SUBJECT: REVIEW OF, "NNWSI PHASE II MATERIALS INTERACTION TEST  
PROCEDURE AND PRELIMINARY RESULTS", ANL-84-81, JANUARY  
1985, BY J.K. BATES AND T.J. GERDING

DATE: September 11, 1985  
TO: Files - NWM-MF-#32  
FROM: P. Soo *P.S.*  
SUBJECT: Review of "NNSI Phase II Materials Interaction Test Procedure and Preliminary Results," ANL-84-81, January 1985, by J.K. Bates and T.J. Gerding

A review was carried out on the subject report, which describes a test methodology to obtain radionuclide release rate data for waste packages under tuff repository conditions. Below are given general and specific comments on the manuscript.

**SCHEMATIC OF POSSIBLE TEST APPARATUS**

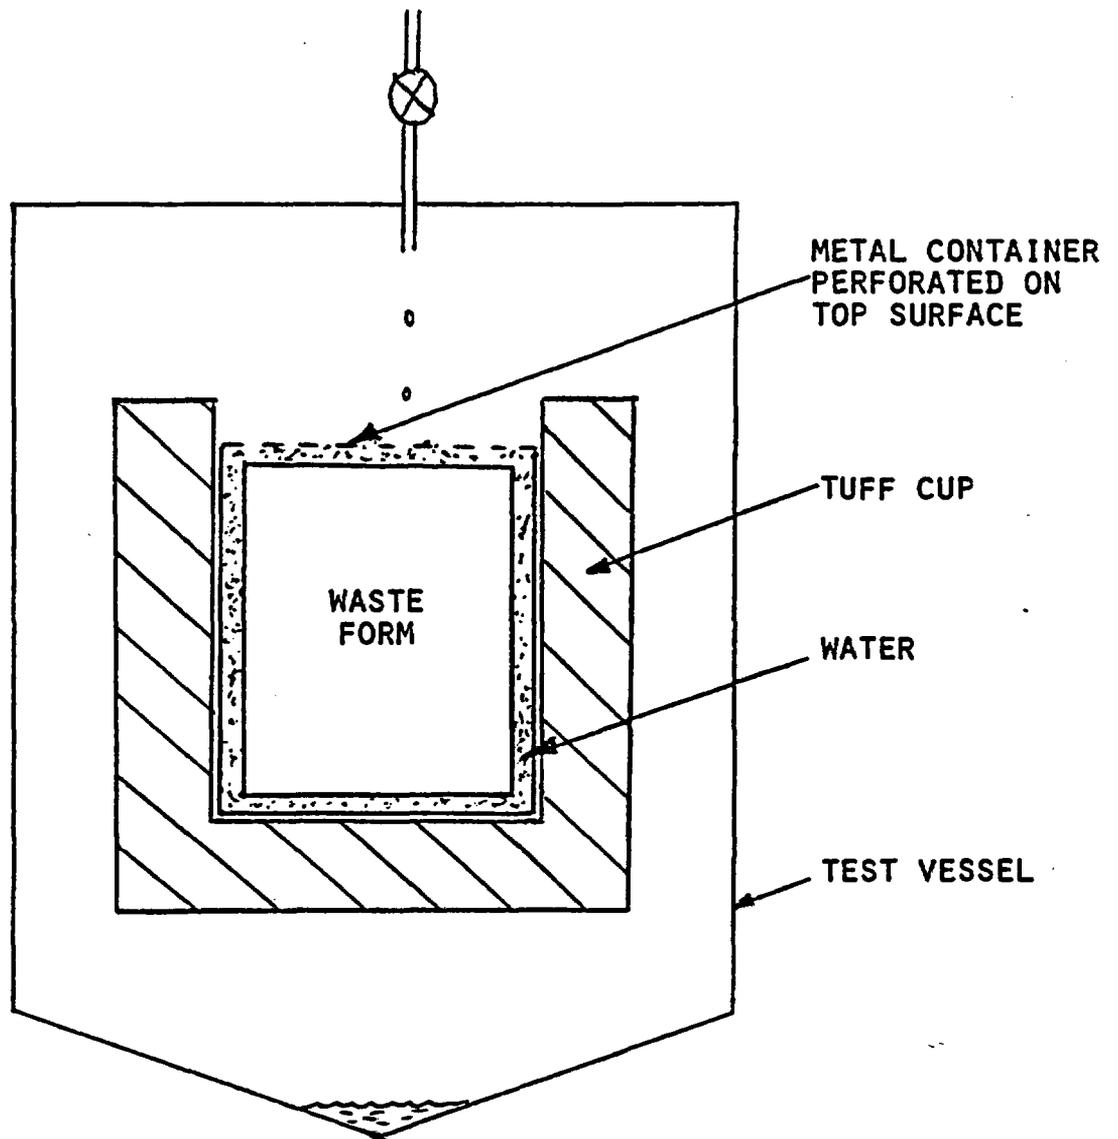
3. A possible alternate analog test configuration is attached in which the waste form is completely surrounded by container material except for the top surface. The assumption made is that the top surface of the container will corrode most quickly because it has longer contact

with water percolating from above. After breaching of the container the space between the waste form and container will become filled with water giving rise to leaching. If the drip rate of water into the container is very slow the solution will become saturated with radionuclides. The rate of release of radionuclides will depend on the rate at which water overflows from the top of the container. These release rates will probably be conservative.

This configuration will also minimize the potentially serious problem of water evaporation from the waste form (which Bates describes in Section 5.0 of his report) since most of the leachant will be trapped within the container leaving a smaller free surface for evaporation.
